UNITED STATES
DEPARTMENT OF THE INTERIOR
BUREAU OF LAND MANAGEMENT
SUNDRY NOTICES AND REPORTS ON WELLS

HORSESHOE GALLUP #25

Attachment to notice of Intention to Abandon:

Well: 25 Horseshoe Gallup Unit

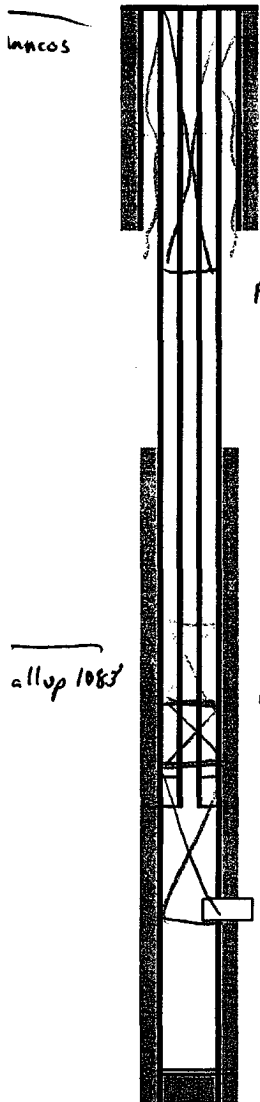
1. Plugging operations authorized are subject to the attached "General Requirements for Permanent Abandonment of Wells on Federal and Indian Lease."
2. Mike Flanikan with the Farmington Office is to be notified at least 24 hours before the plugging operations commence (505) 599-8907
3. The following modifications to your plugging program are to be made:
 - a) Bring the top of the Gallup plug to 1033' .

- BLM geologist's pick for the top of the Gallup fm. reflects the top of the transitional Tocito interval in this well. This top varies from operator's pick in this well.
- It is recommended that the Gallup top in this report be adequately covered with cmt.

allup 1083' plug 1254 - 1033 $(221 + 587) / 7.299(1.18) = 31 \text{ SKS}$
